BODE RAINIER

SDCI # 3038509-LU MASTER USE PERMIT

S38 BODE RAINIER
RESIDENTIAL APARTMENT

This is a consolidated summary of all review comments for this review cycle. Please respond to each comment and resubmit this as a response plan set along with your new, updated plans.

1 SITE PLAN - CONCEPTUAL EXCAVATION

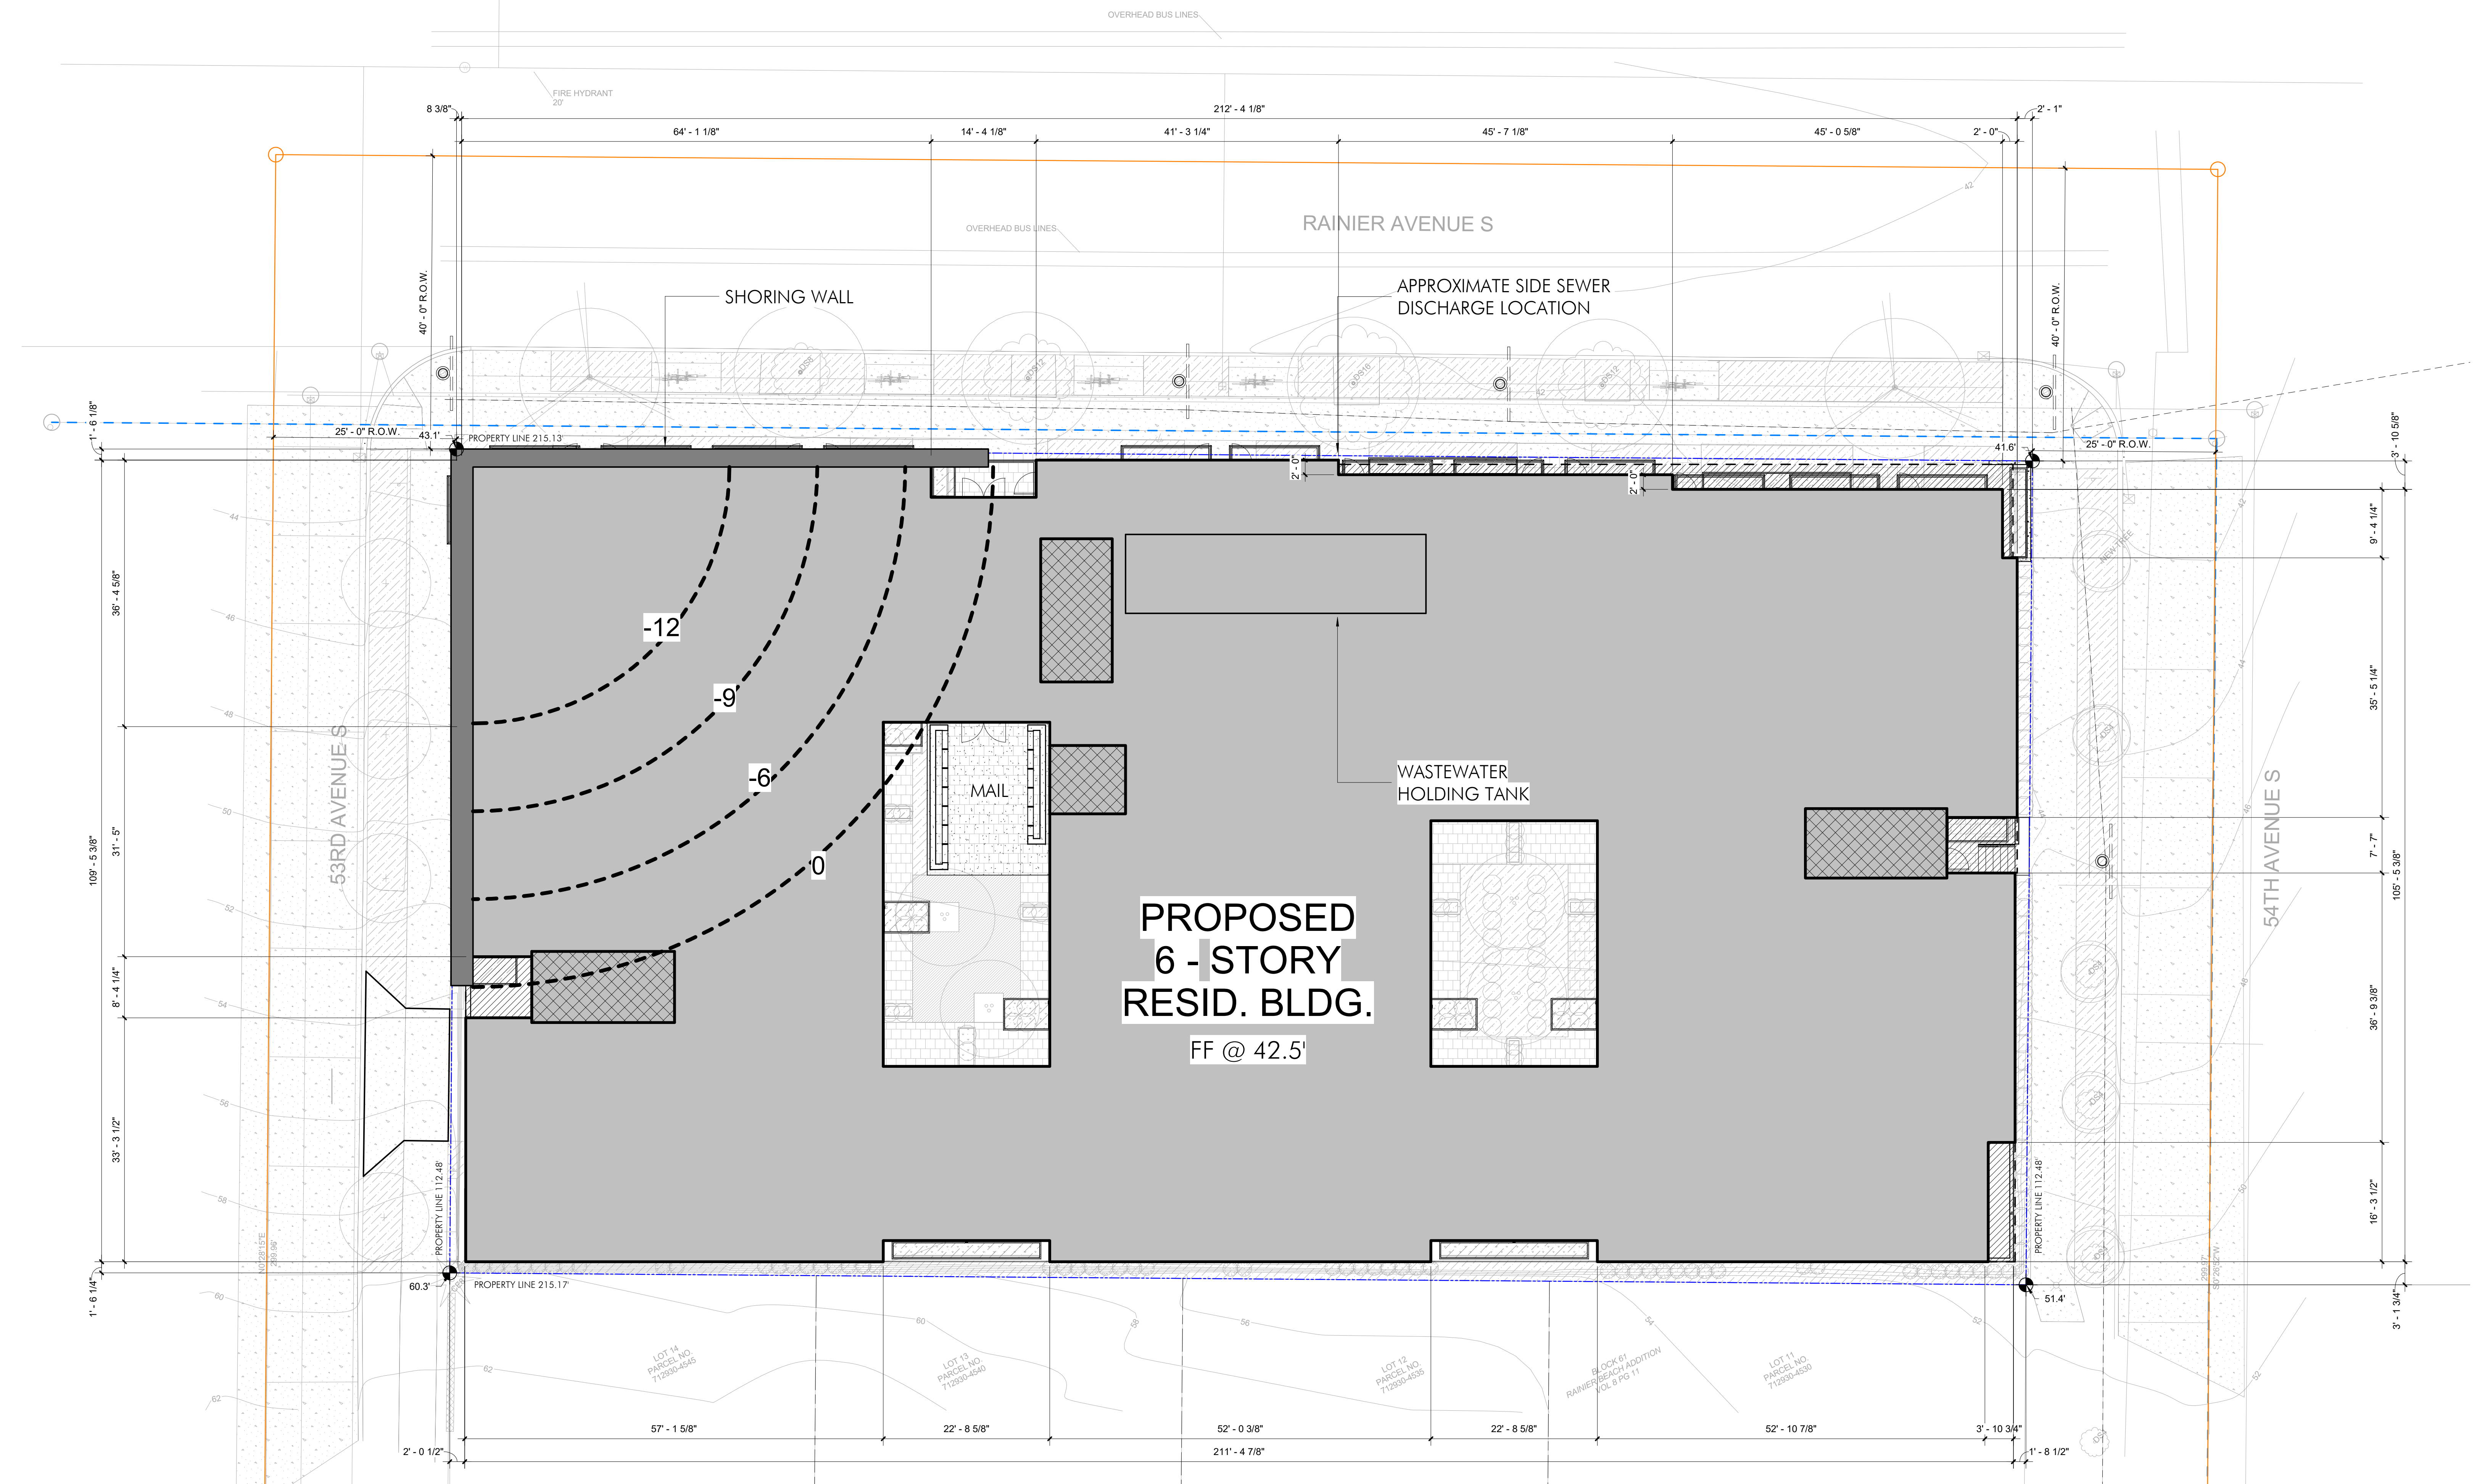
SEPA check list show there is a document named "Investigation/Feasibility Study/Cleanup Action Plan, April 14, 2021". Please upload it.

If yes, please provide conceptual temporary active dewatering plan in the MUP plan set. The plan should indicates, in concept, the planned dewatering methods and dewatering system elements. Please have geotechnical engineer provide an assessment of dewatering impact on adjacent properties based on the conceptual dewatering plan.

LEVEL 1 FLOOR
PLAN

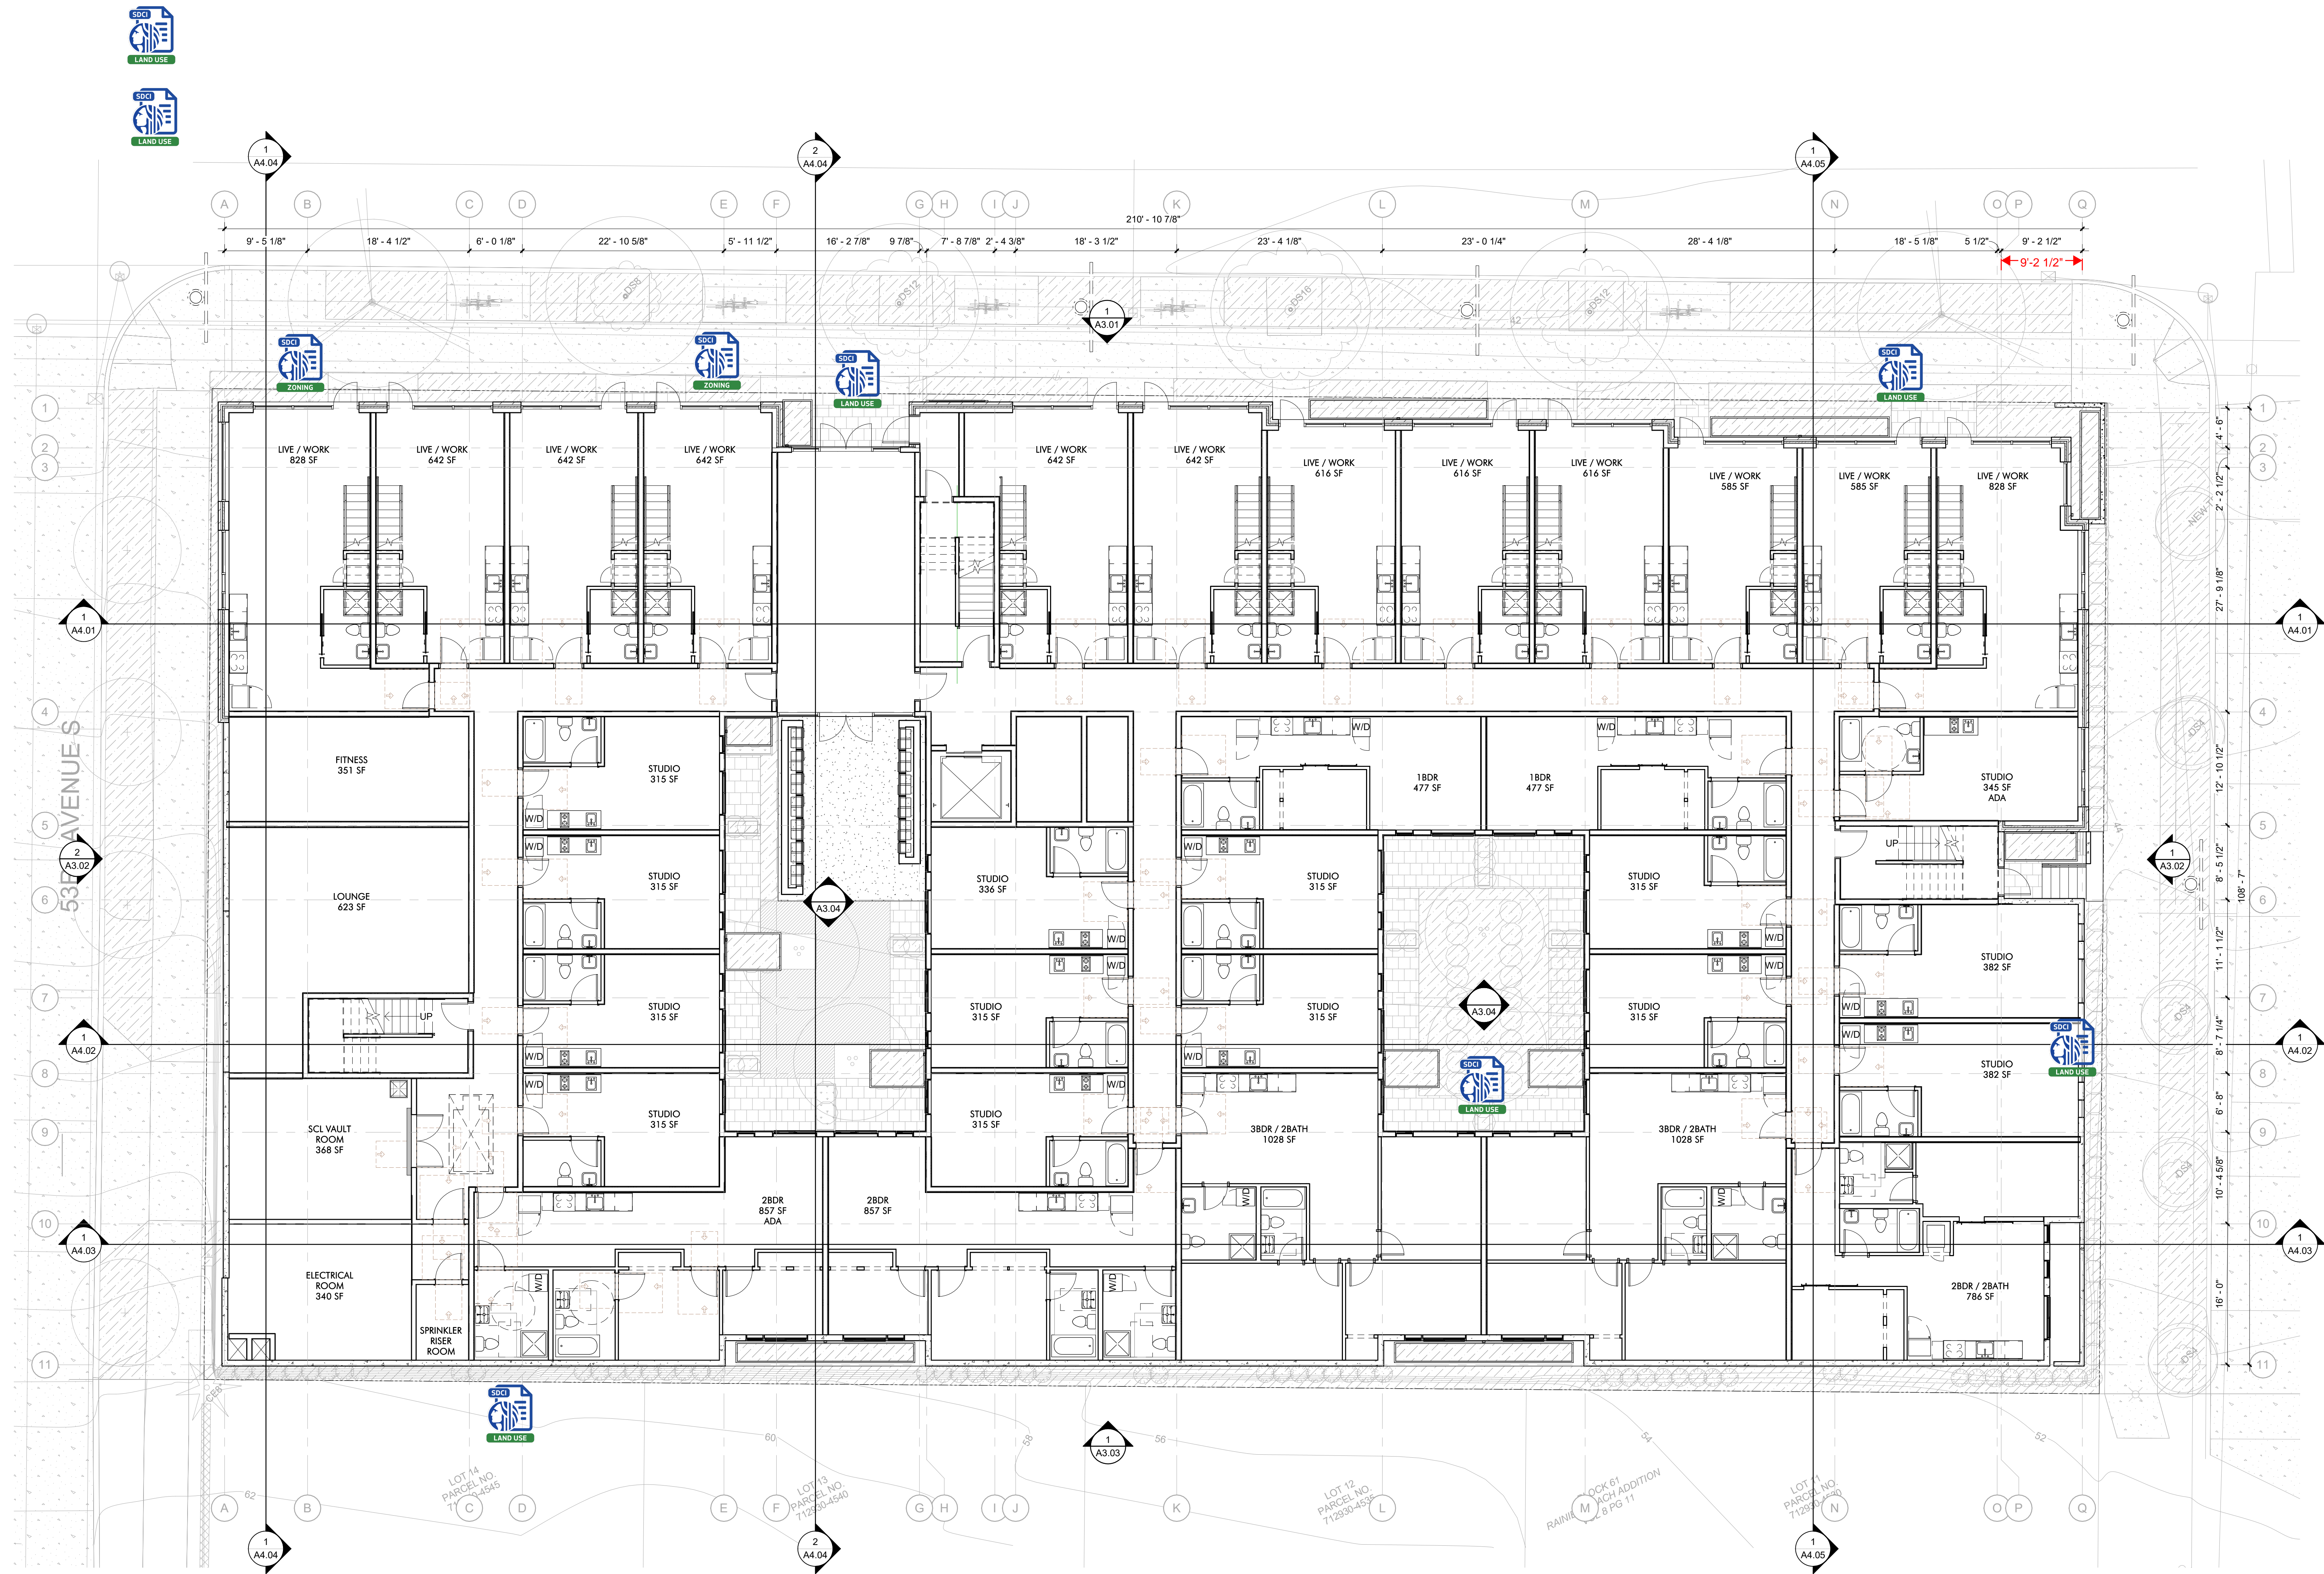
<div><div></div></div>	<div><div>Subject: General Land Use Review Comment</div><div>Page Index: 24</div><div>Author: David Sachs</div><div>X: 5.0473 in</div><div>Y: 6.1787 in</div><div>Layer: Review Comment</div><div>Review Type: Land Use</div></div>	<div>Dimension all facade widths, modulation widths and depths, courtyards, walkways, patios, terraces, decks and other architectural features on all floor plans. Include dimensions to property lines.</div>
<div><div></div></div>	<div><div>Subject: General Land Use Review Comment</div><div>Page Index: 24</div><div>Author: David Sachs</div><div>X: 29.8183 in</div><div>Y: 9.8124 in</div><div>Layer: Review Comment</div><div>Review Type: Land Use</div></div>	<div>It appears that the number of steps and the depth of setback has been greatly reduced since EDG 2. Provide rational for this change.</div>
<div><div></div></div>	<div><div>Subject: General Land Use Review Comment</div><div>Page Index: 24</div><div>Author: David Sachs</div><div>X: 23.8804 in</div><div>Y: 19.9158 in</div><div>Layer: Review Comment</div><div>Review Type: Land Use</div></div>	<div>It appears the courtyard has been significantly reduced in length since EDG 2. Provide a rational for this.</div>

These three units were shown recessed with landscaping and terraces at EDG 2. Provide rational for the change and how this revised condition better addresses the street frontage.

The width of this recess has been significantly been reduced since EDG 2 from 22'-8" down to 14'-6". Provide a rational how this reduced width responds to guidance and creates a better modulated mass.

Provide more information on the property line condition. Will there be retaining walls or a fence, and if so, how will the landscape and light well be accessed?

Provide spot elevations at the corners of the building, at all entrances, patios, terraces, courtyards, top and bottom of light wells and major retaining walls, and any other changes on grade.
